SERVICE BULLETIN

263

SUBJECT: Capacitor change required when converting between 50 and 60 HZ.

MODELS AFFECTED: 5.4/6.5 SBCG (Safe-CO®) and 5.8/7.0 BCGD (carbureted)

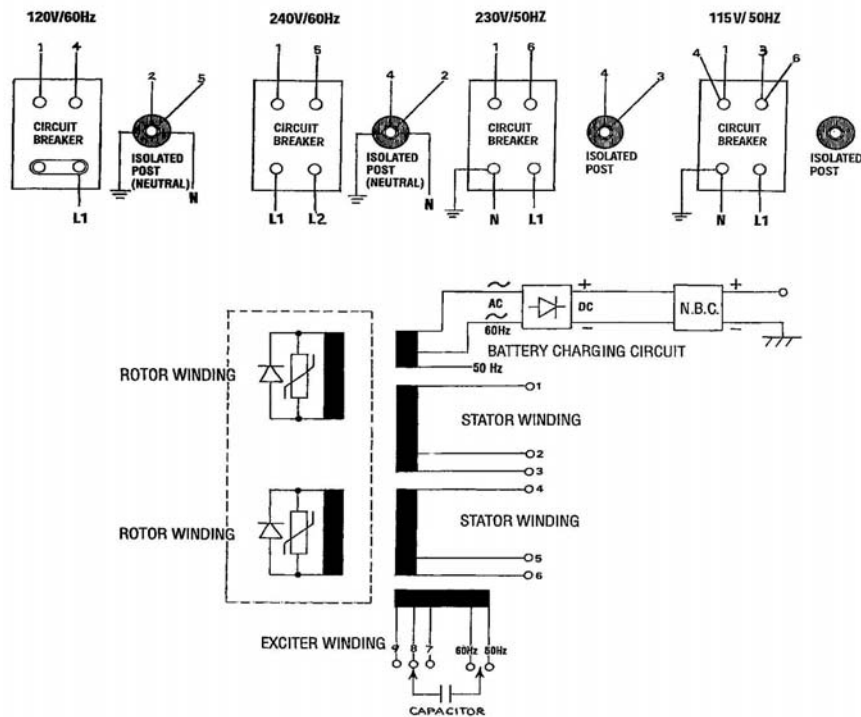
The capacitor is different depending on the hertz. The capacitors **MUST** be changed to insure proper voltage output.

Please follow the conversion guidelines found in the respective Operator's Manual making sure to change the output wiring and engine speed accordingly.

Standard 60 hertz capacitors are 35 MF, part number 49627. For 50 hertz use 40 MF, part number 46639.
